**OCD-HOBBSCOCD**  
**SUNDRY NOTICES AND REPORTS ON WELLS**  
*Do not use this form for proposals to drill or to re-enter an abandoned well. Use form 3160-3 (APD) for such proposals.*

Cimarex proposes to add Seven Rivers perms at 3932' - 4404' and convert well to a SWD. See attached current and proposed WBD's. C-108 is in progress and will be sent in under separate cover.

**MALLON '35' FED #1**

**Mallon 35 Fed #1  
30-025-32983  
Cimarex Energy Co. of Colorado  
October 14, 2009  
Conditions of Approval**

**Proposed New Perforations**

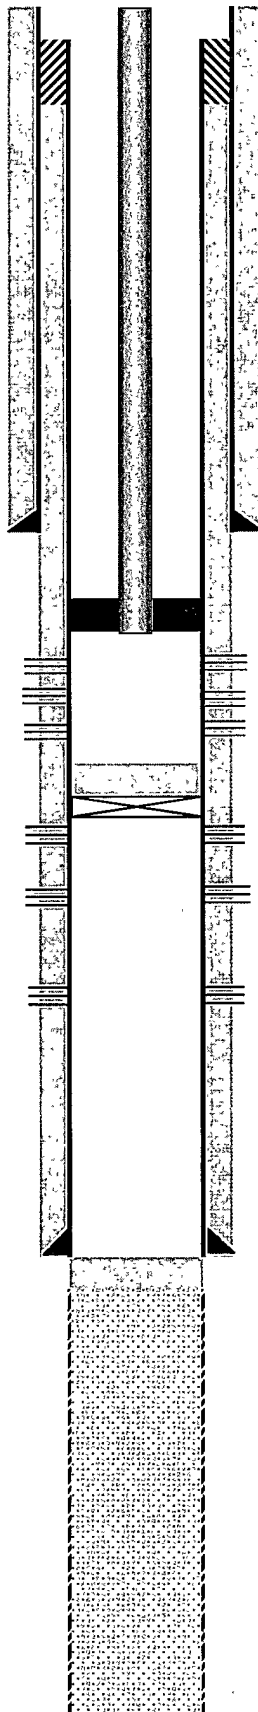
**After 4-2-2010 the well must be online or plans to P & A must be submitted.**

- 1. Surface disturbance beyond the existing pad must have prior approval.**
- 2. Closed loop system required.**
- 3. Operator to have H2S monitoring equipment on location as H2S has been reported from surrounding wells.**
- 4. A minimum of a 2M BOP is required and must be tested prior to performing work.**
- 5. Subsequent sundry required.**
